EASTGATE COMMERCIAL PARK, PHASE II

FINAL DEVELOPMENT PLAN

Re: Project 611-659 Eastgate Commercial Park, Phase II – Final Development Plan

RE: Project 611-659 Eastgate Pkwy Final Development Plan

SCHEMATIC PLAN

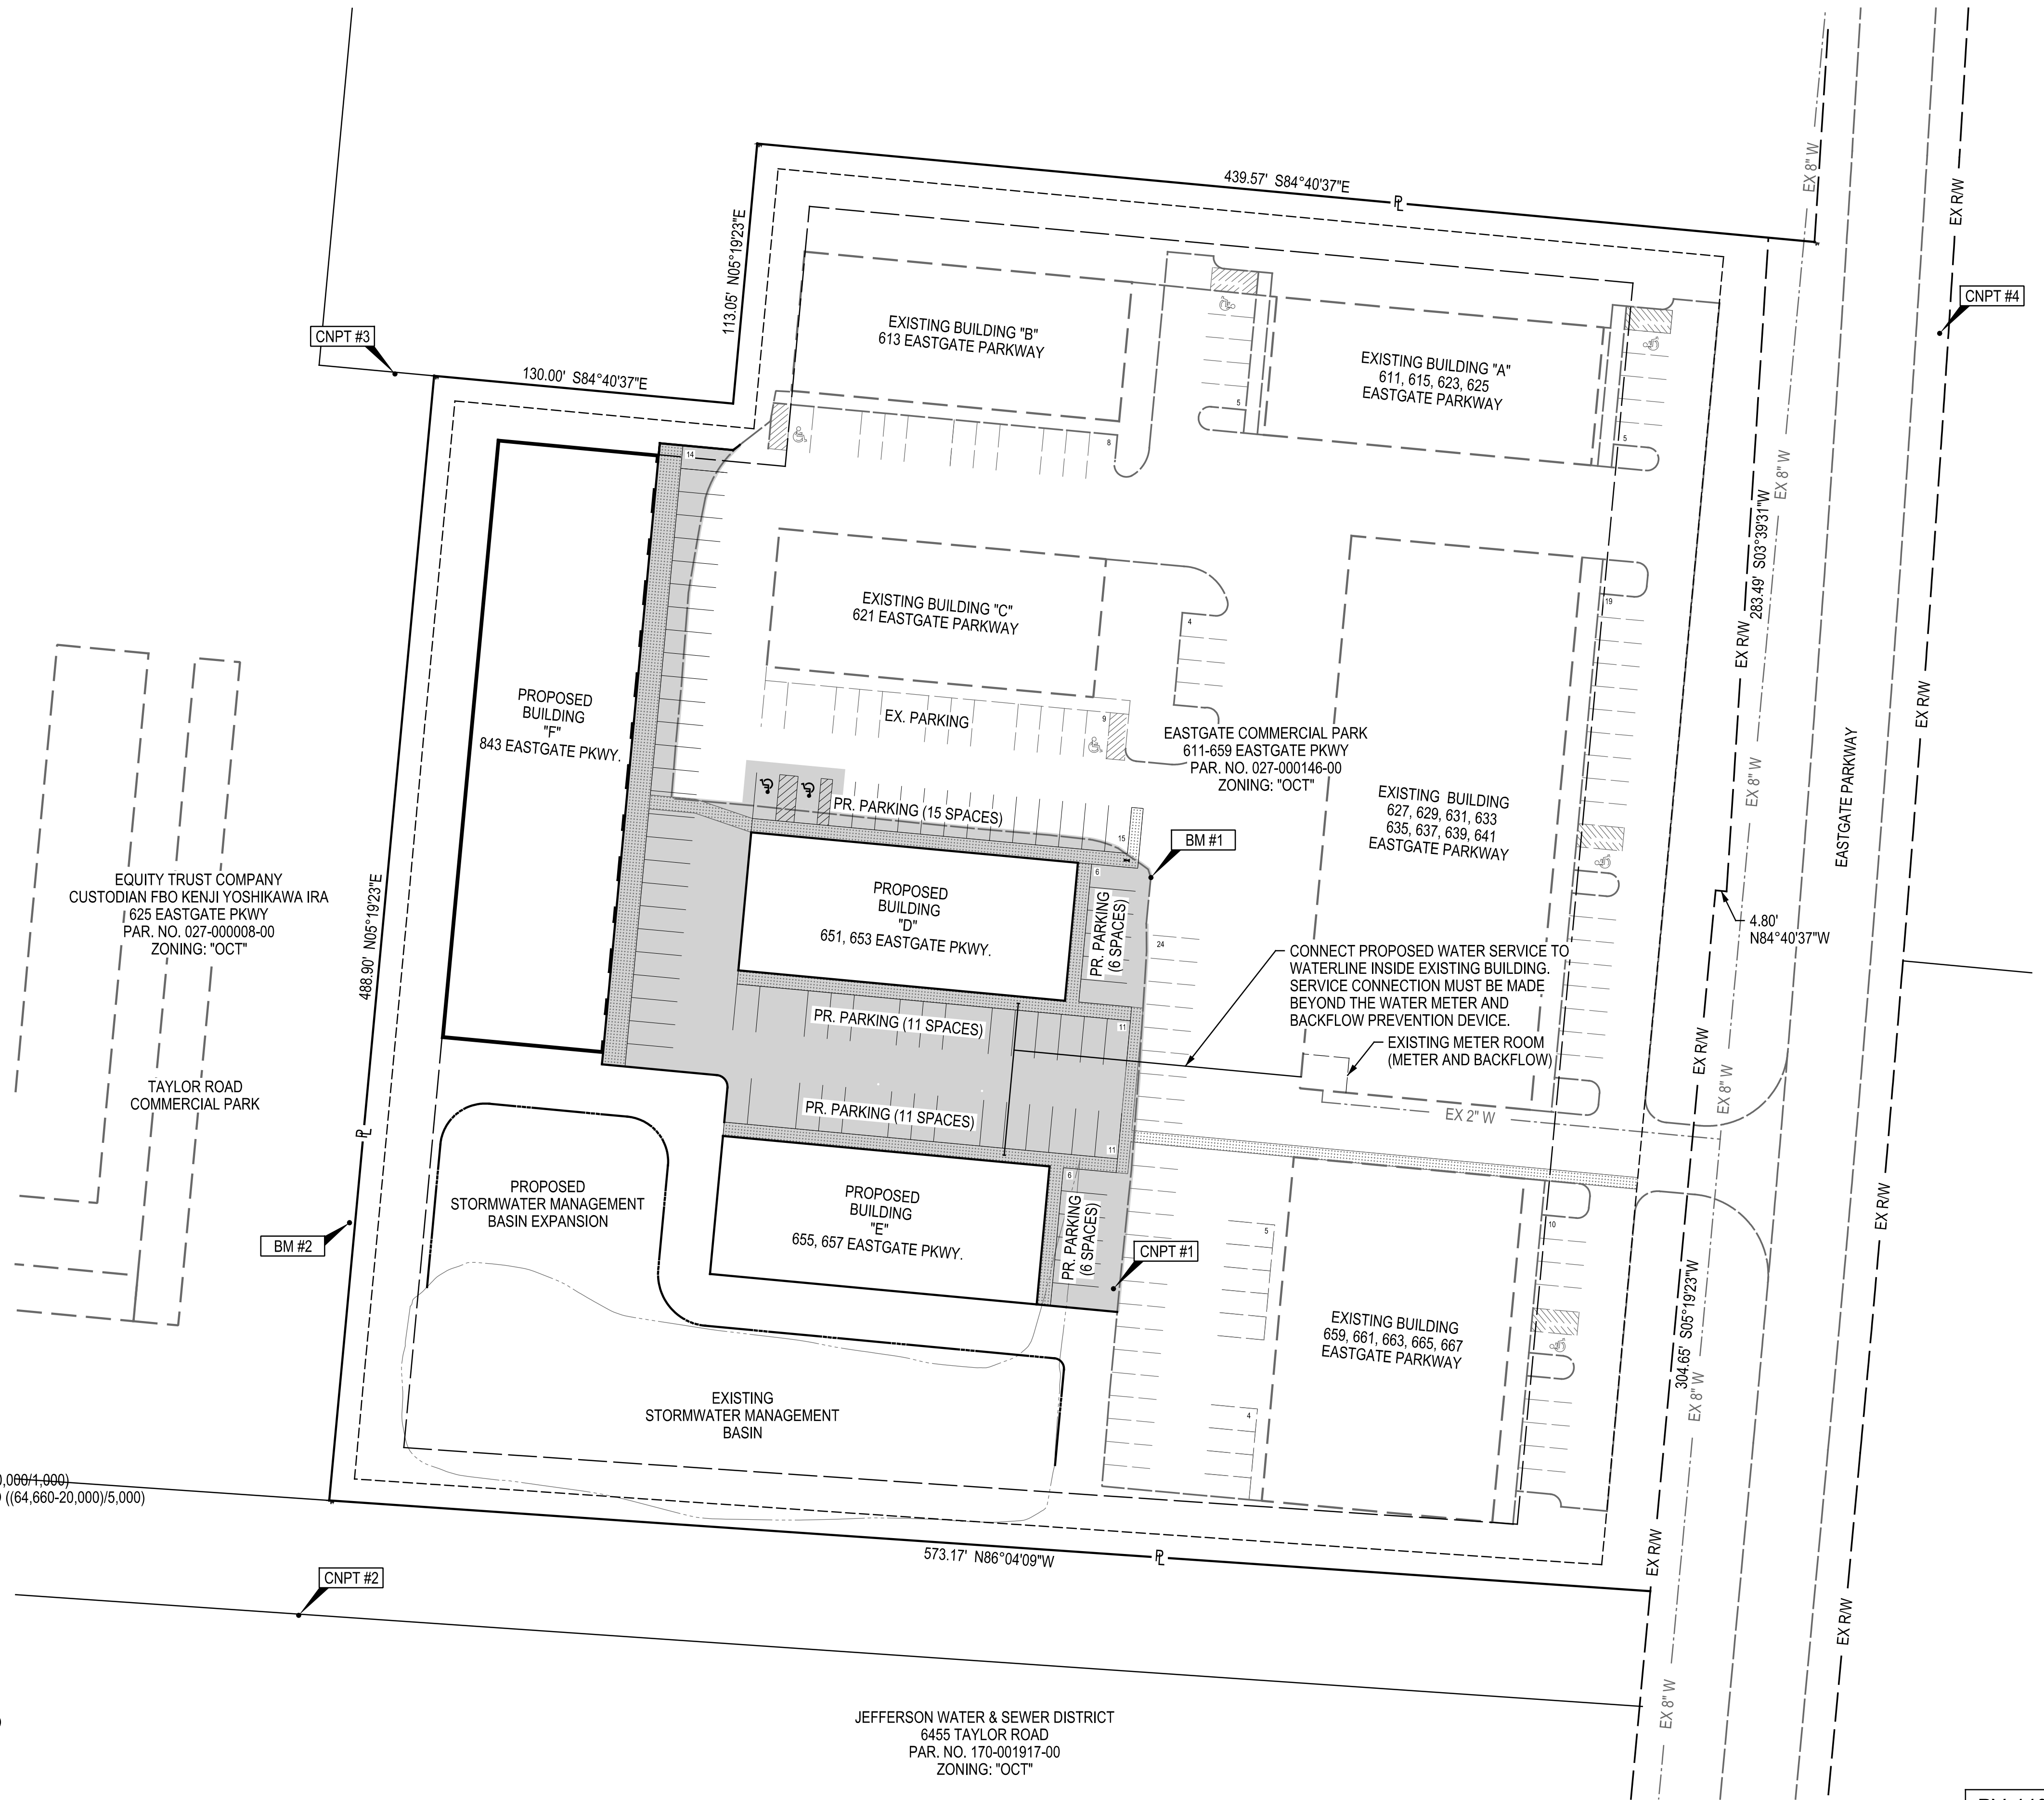
3. Provide parking calculations for all buildings on site to ensure that the minimum amount of spaces are met for the entire property. Include all applicable parking ratios per Section 1163.02 including the "1 space per business vehicle" requirement.
Calculations have been added, please see sheet 4.
4. The parking calculations indicate two 8,250sqft buildings. The provided building dimensions of 60' x 142' come to 8,520sqft. Please clarify and revise as necessary to make sure the building area is consistent.
Building are label has been corrected accordingly.
5. Clearly show on the site plan where the new parking spaces are being proposed.
Additional labels have been added to the plan, see sheets 4 & 5.

3. Provide parking calculations for all buildings on site to ensure that the minimum amount of spaces are met for the entire property - not just for the 3 buildings proposed. Include all applicable parking ratios per Section 1163.02 including the "1 space per business vehicle" requirement and indicate the amount of spaces provided for the entire site. *Parking spaces have been reviewed and noted accordingly.*

4/13/2022 - Parking is calculated incorrectly. Please review the warehouse parking ratios in Section 1163.02 of the zoning code and revise accordingly. For example, roughly 100,000sqft of building area will be on the property. Minimum parking is 1 per business vehicle + up to 20,000sqft - 1 per 1,000sqft + 20,001-120,000 - 1 per 5,000sqft + over 120,000sqft - 1 per 10,000sqft. 36 parking spaces are required without considering the 1 space per business vehicle. **Parking calcs have been updated accordingly.**

20+3+12=35 SPACES REQUIRED.
 SPACES PROVIDED =63 SPACES(61 STANDARD)
 (2 HANDICAP)
 17 SPACES REMOVED

SITE PLAN

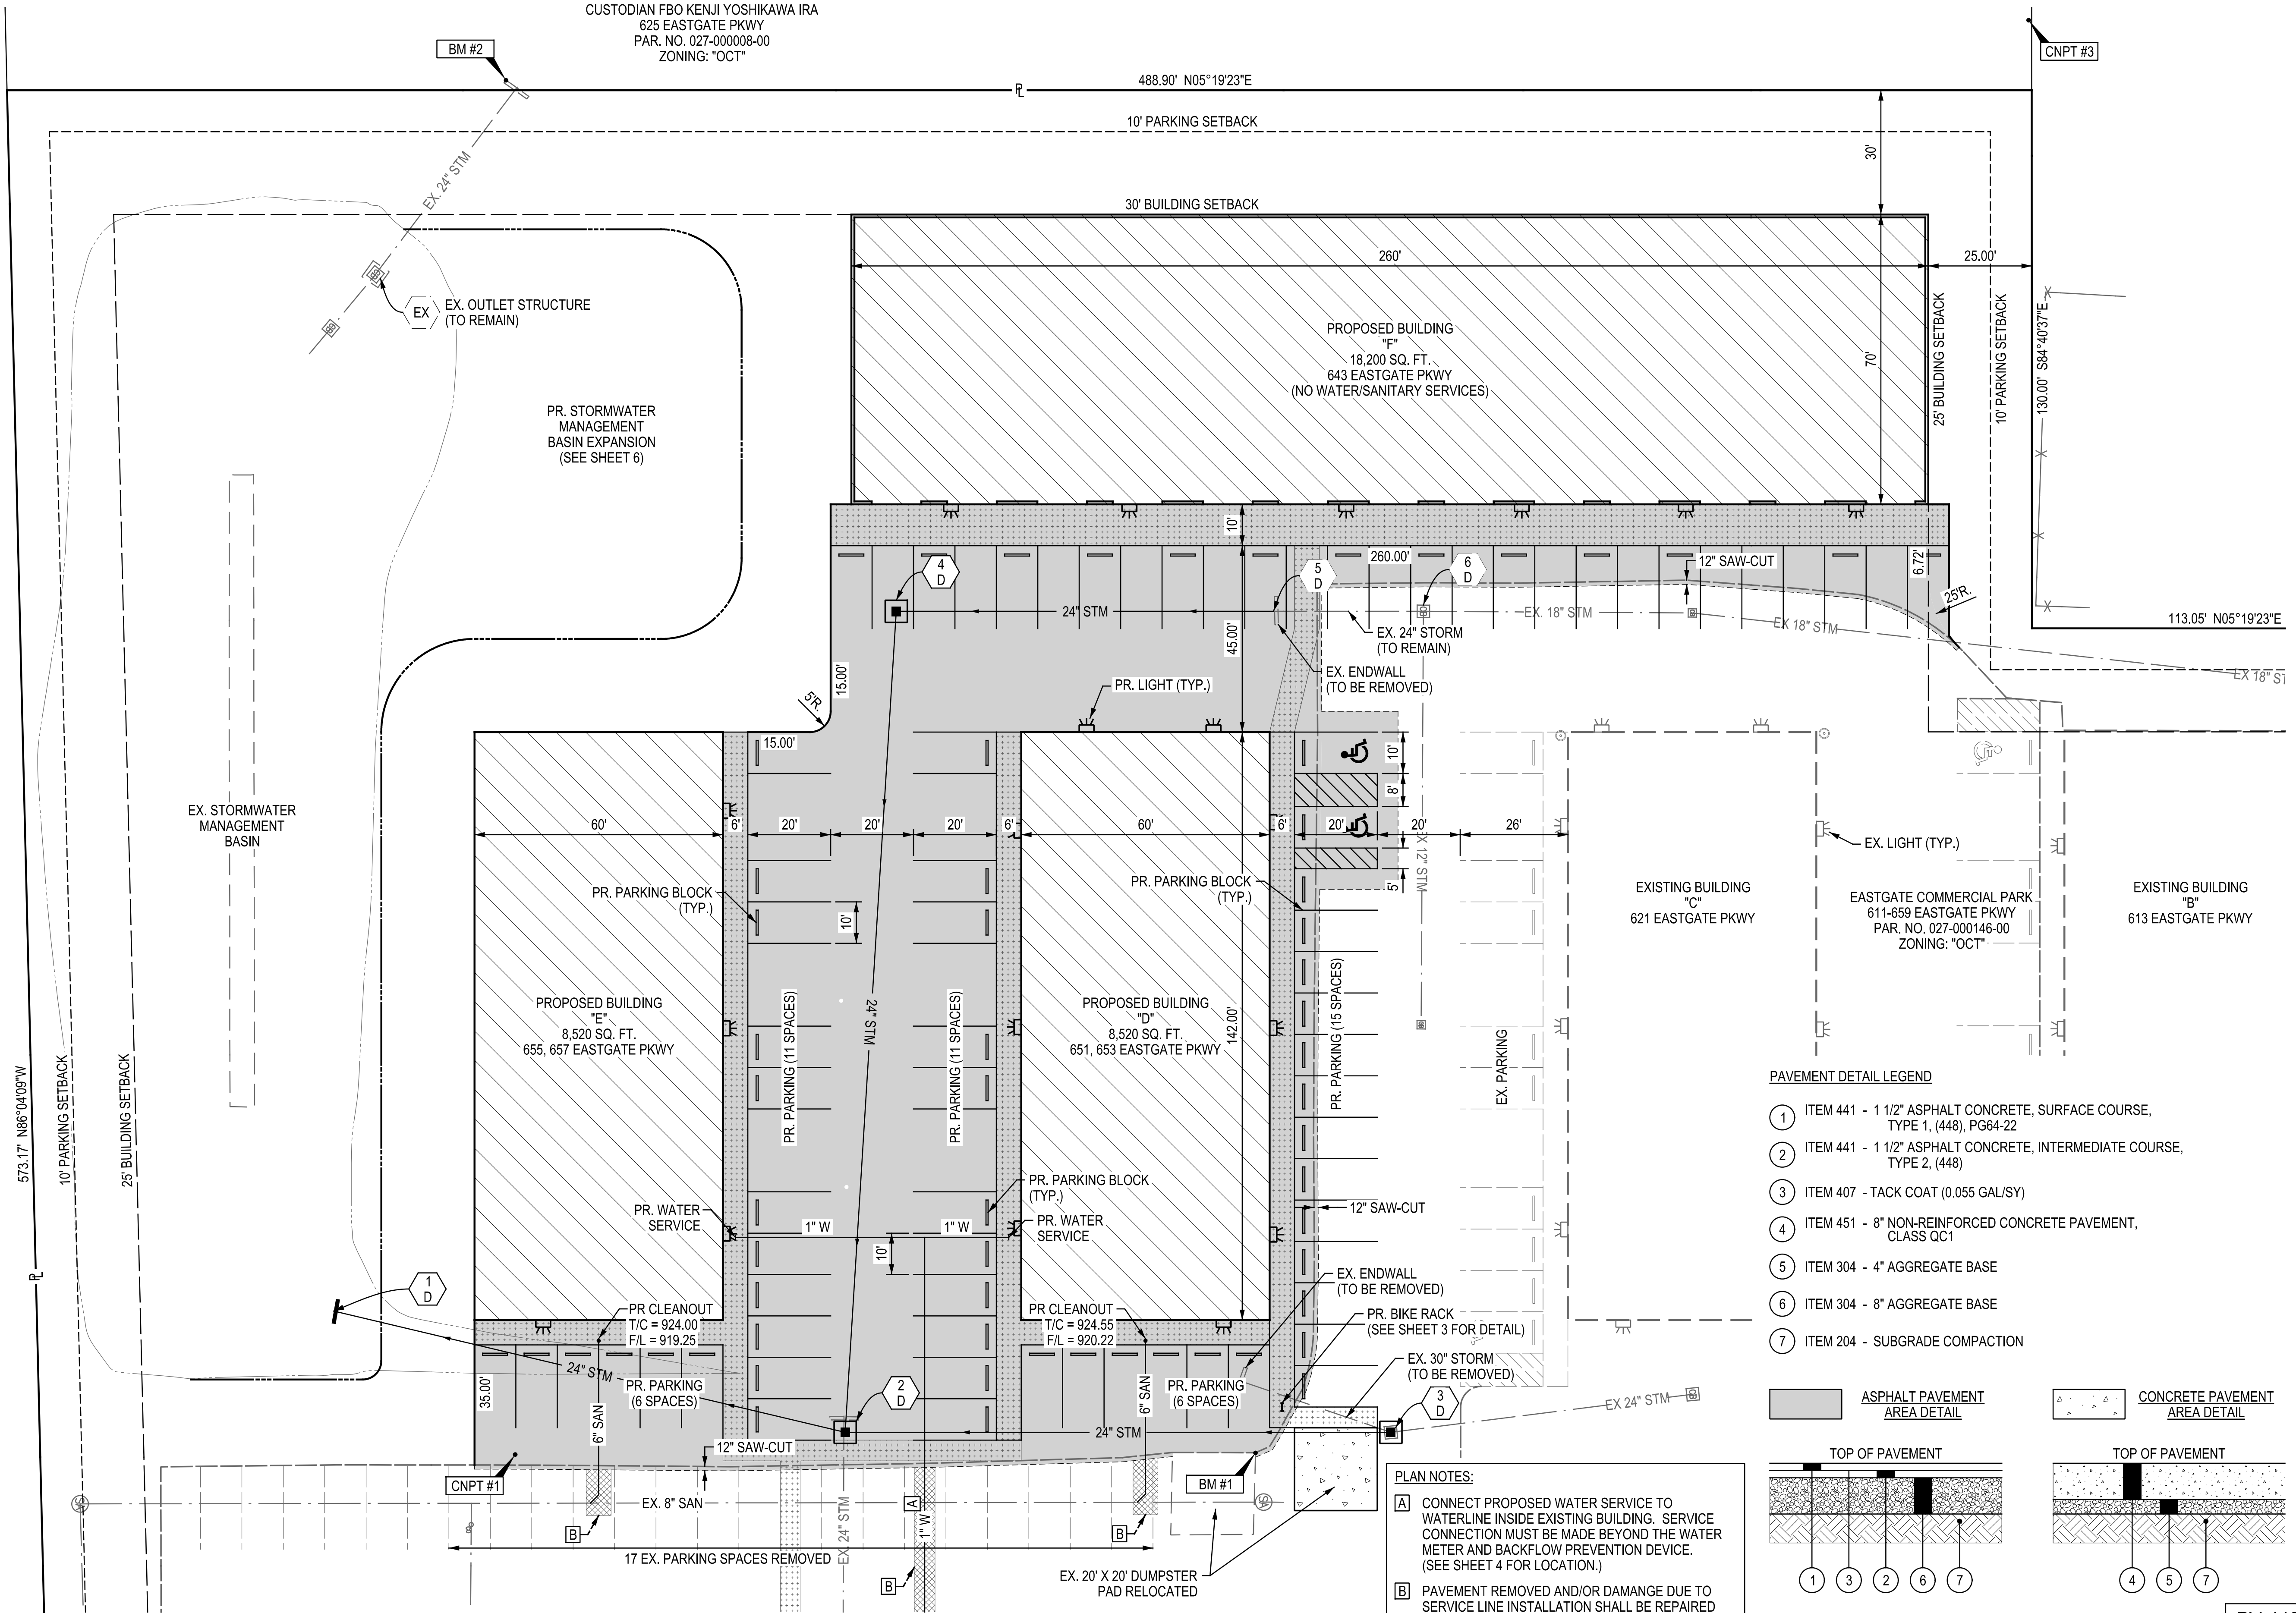
8. Chapter 1155.04(g) requires bike racks to be placed within 600' of the entrance to each building. Please revise the site plan to include bike racks.
Bike rack added, see sheet 5 for location, detail added to sheet 3.

6. Chapter 1155.04(g) requires bike racks to be placed within 600' of the entrance to each building. Please revise the site plan to include bike racks. Only one bike rack is included in the site plan. *Updated Accordingly.*
